# SERVICE BULLETIN

No. 315

Subject:  $V_{ne}$  Airspeed Limit

Models Affected: PA-30 Twin Comanche

SK-2202

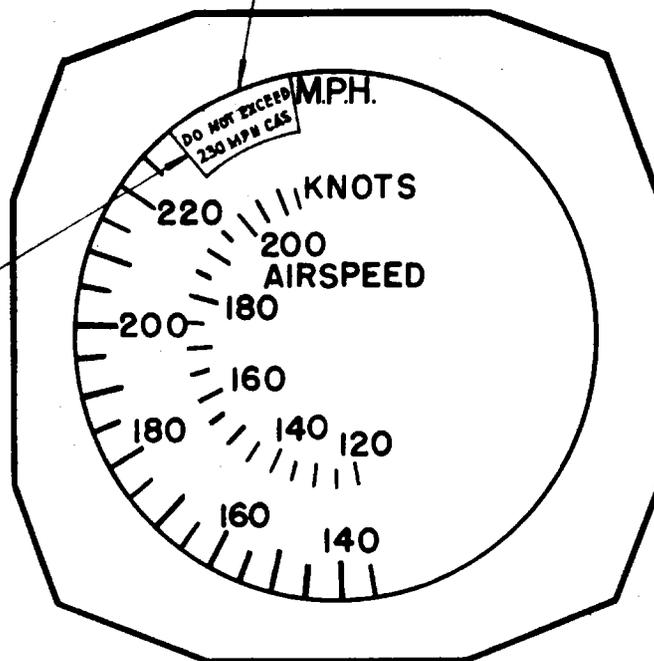
Purpose: To revise the existing  $V_{ne}$  Airspeed Limit of 245 mph C.A.S. to a  $V_{ne}$  Airspeed Limit of 230 mph C.A.S.; reference FAA Airworthiness Directive dated July 2, 1970.

Instructions: Install airspeed indicator placard part number SK-2202 on the face of the airspeed indicator, as denoted by the sketch on the reverse side of this bulletin.

Install Placard SK-2202 on the face of the Airspeed Indicator as shown.

Locate this edge of Placard SK-2202 at 230 M.P.H.
